Sequoyah Nuclear Plant, Units 1 and 2
Facility Operating License Nos. DPR-77 and DPR-79
NRC Docket Nos. 50-327 and 50-328

Subject: Application to Revise Technical Specification 6.8.4.h, "Containment Leakage Rate Testing Program," (SQN-TS-14-03) (TAC Nos. MF5366 and MF5367), Response to Request for Additional Information

Response to Request for Additional Information

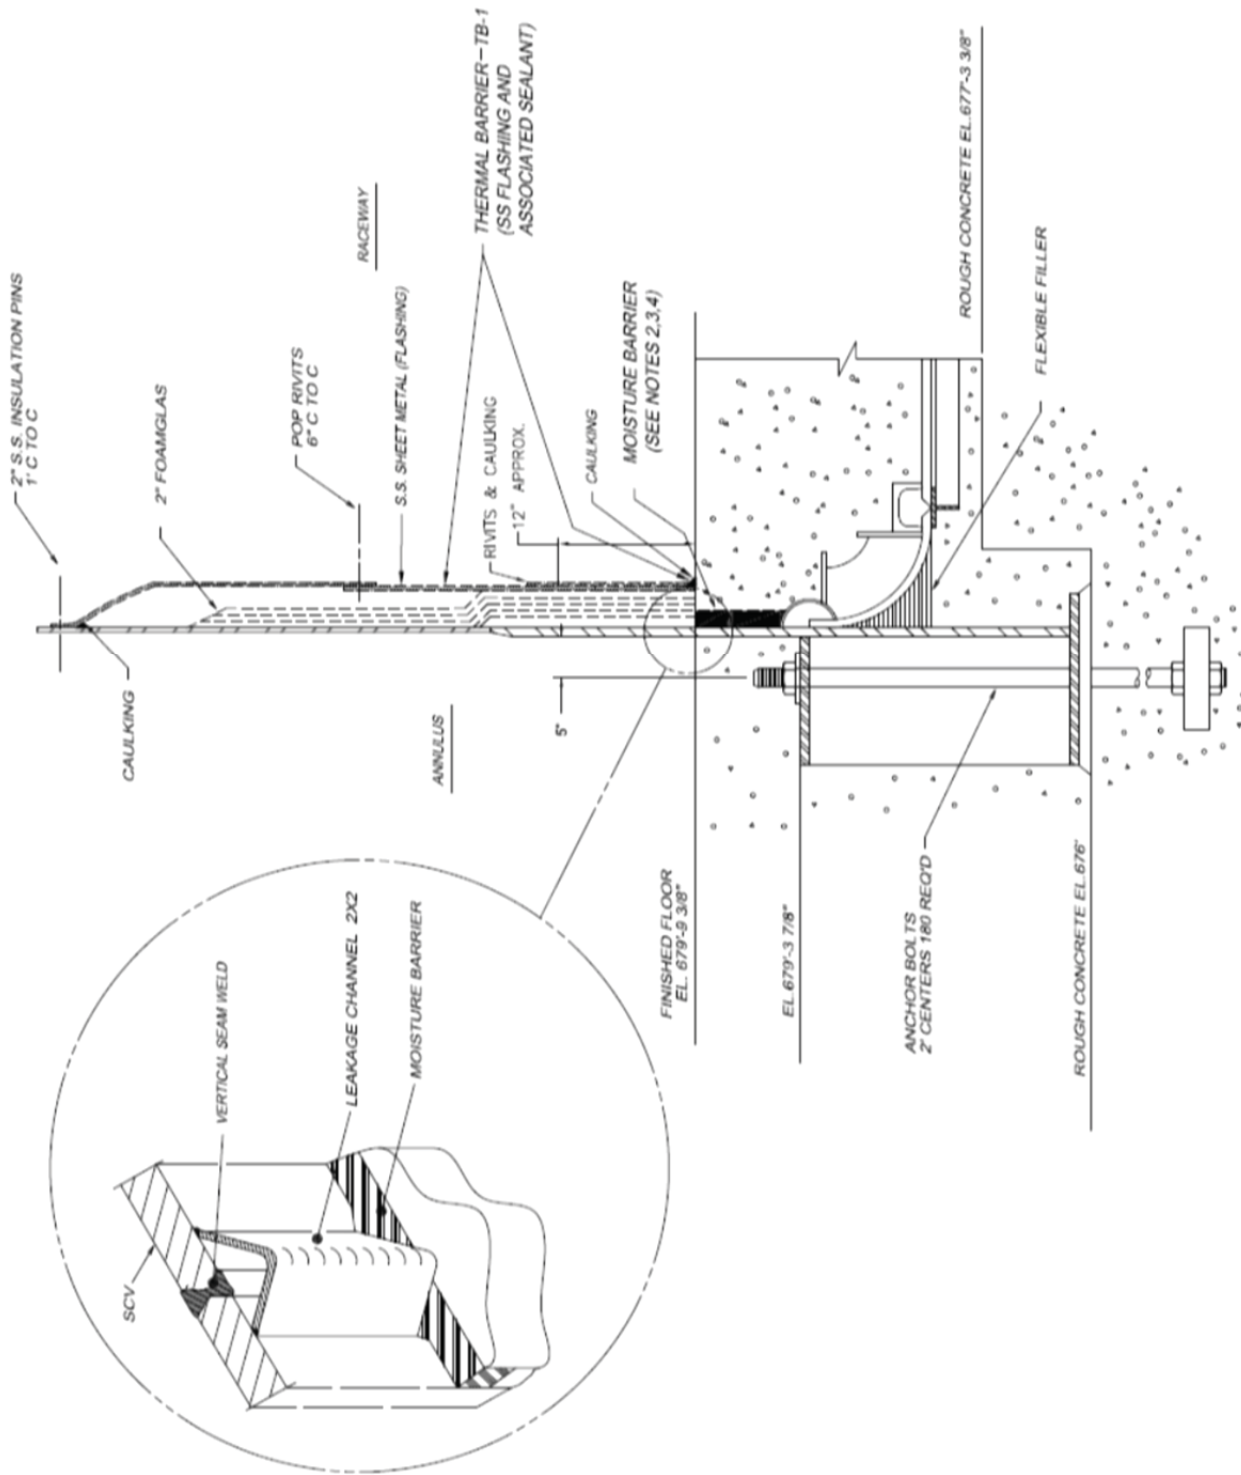
- b. The LAR does not have specific details to determine whether the inspections covered both interior and exterior moisture barriers at the interface of the containment vessel wall and concrete.*

The moisture barrier is intended to prevent intrusion of moisture against inaccessible areas of the pressure retaining metal containment shell or liner at concrete to metal interfaces that are not seal welded. The moisture barrier is the sealant between the concrete to metal containment interface in the raceway behind the metal flashing. The raceway is an area inboard of the SCV between the Polar Crane Wall and the SCV on the bottom elevation of containment used for access to the accumulator rooms, fan rooms, and inside the polar crane wall. An examination of the moisture barrier is performed each inspection period. The flashing covering the moisture barrier is removed to allow access for examination.

The SCV to concrete interface is visible in the Annulus. The annulus is the area in the reactor building between the SCV and the concrete shield building. No moisture barrier covers the SCV to concrete interface in the Annulus. The metal to concrete interface is examined in the Annulus each inspection period. The following detail provides a representation of the internal and external SCV to concrete interface.
